PREDETERMINATION SETTLEMENT AGREEMENT

CP# 01-19-73107
HUD# 07-19-1017-8

“accessible and usable public and common use areas.”¹ Complainant specifically alleged, in Unit 105, 607 South 17th Street, The Quarters at Ames (“Quarters”), three features in the common areas appeared inaccessible to a person utilizing a wheelchair for mobility, as listed below:²

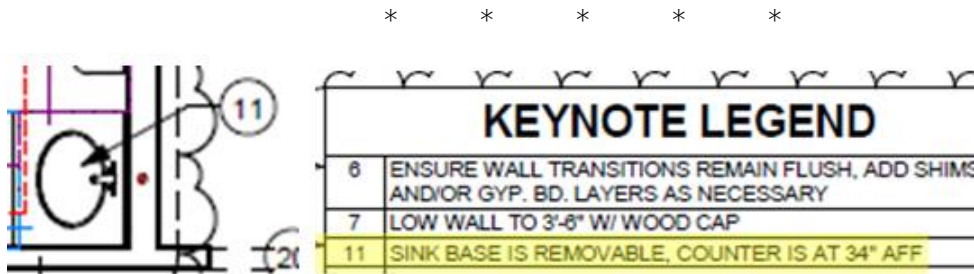
Complaint 2: The cabinets under the bathroom sinks are not removable.

Response: It is our belief that one bathroom in the unit is removable as required by law.

Regarding complaint 2, it is our understanding that Iowa law requires one bathroom cabinet to be removal and we believe we have installed one removable cabinet in Bedroom 3 as shown in the attached floor plan under Key Note 11.
